Addendum No. 1

**Subject: Thurgood Marshall Elementary School
Roof Replacement
SDP Contract No. B-059C of 2016/17**

**Location: Thurgood Marshall Elementary School
5120 North Sixth Street
Philadelphia, Pennsylvania 19120**

This Addendum, dated November 30, 2017 shall modify and become part of the Contract Documents for the work of this project. Any items not mentioned herein, or affected by, shall be performed strictly in accordance with the original documents. This addendum contains two (2) numbered pages, one page of revised specifications, one (1) ADD. #1 Sketch and one (1) Sign-in Sheet for a total of five (5) pages.

ADD. #1

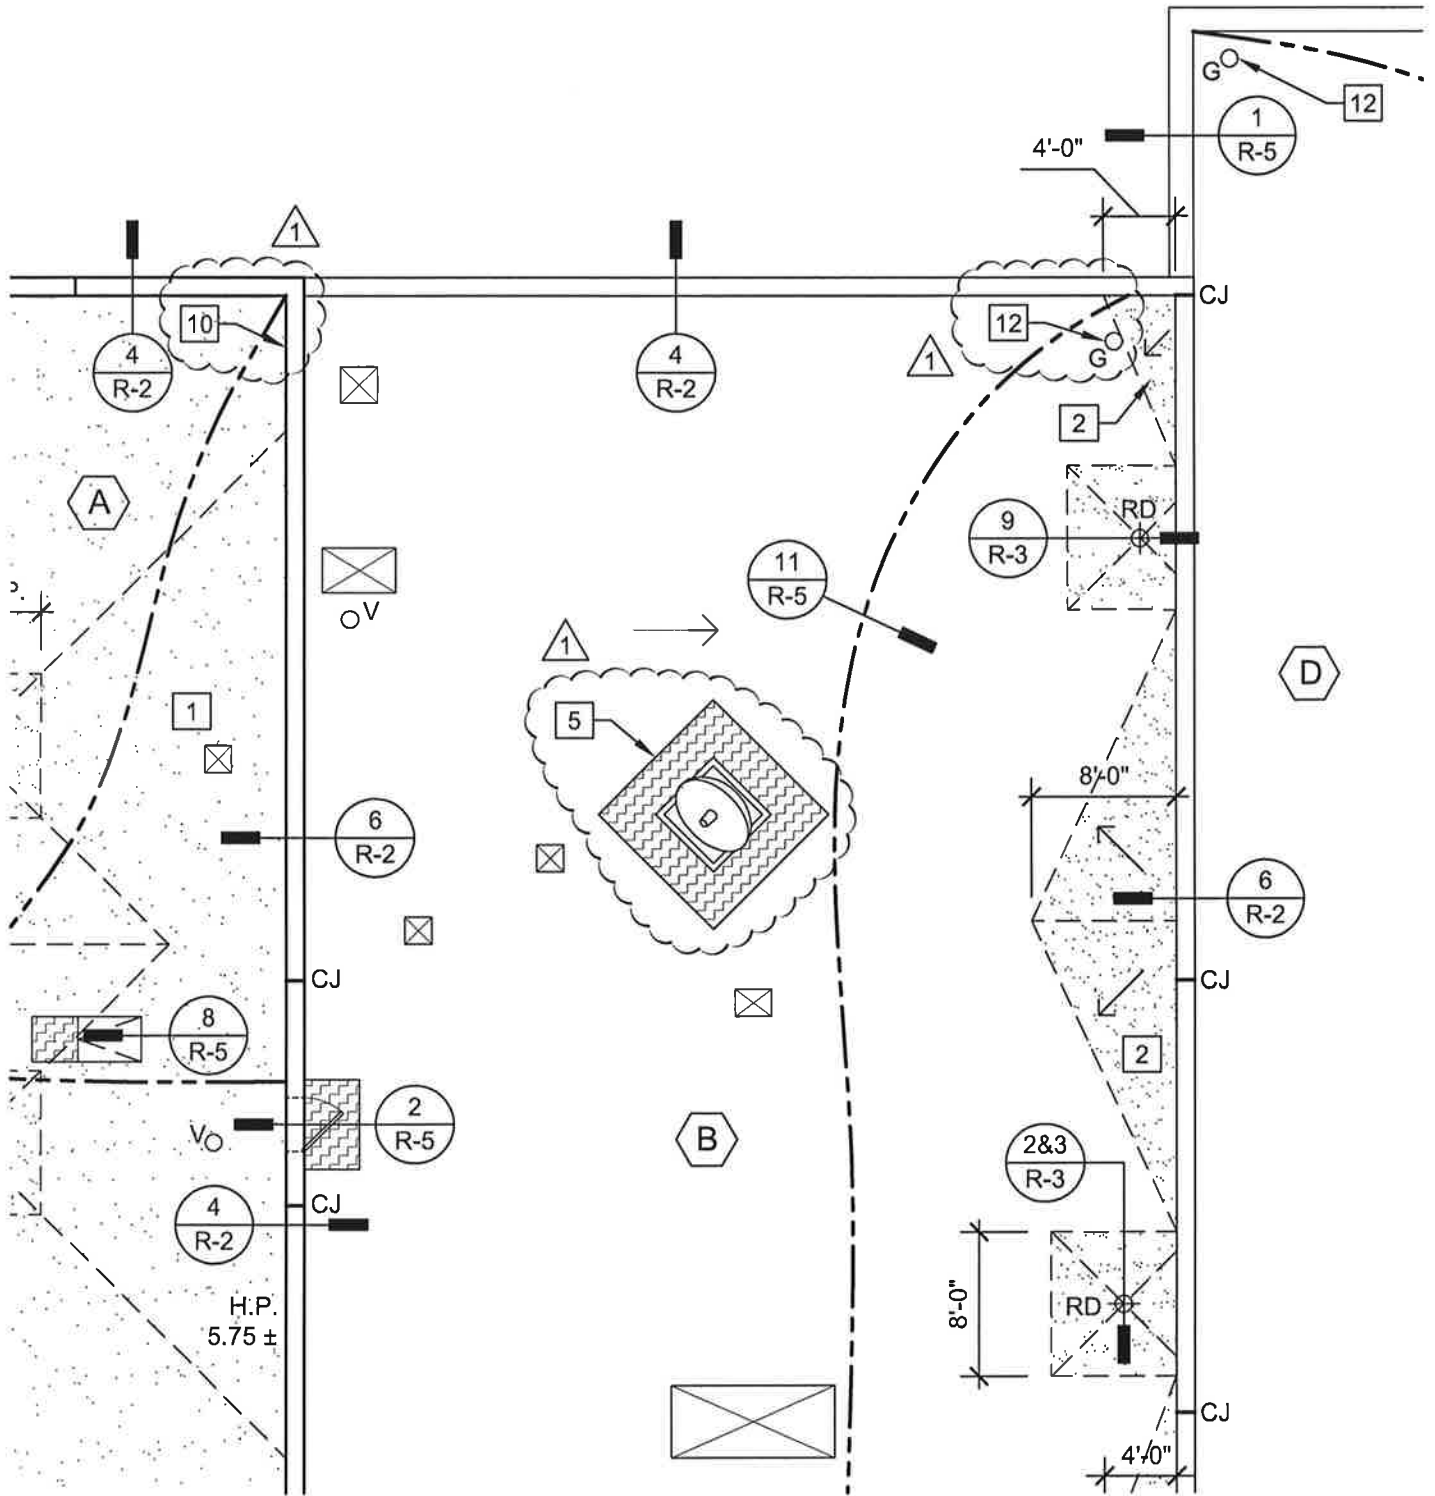
- A. Sheet R-1 (refer to attached partial roof plan drawing ADD. #1)
 - a. Revise key note 5 for Roof Area B to read: Remove and discard abandoned satellite dish, dish support frame, and frame ballast.
 - b. Add key note 10 to northeast corner of Roof Area A.
 - c. At northeast corner of Roof Area B, revise noted legend from S (service line) to G (ground) and add key note 12 to this lightning protection ground post.
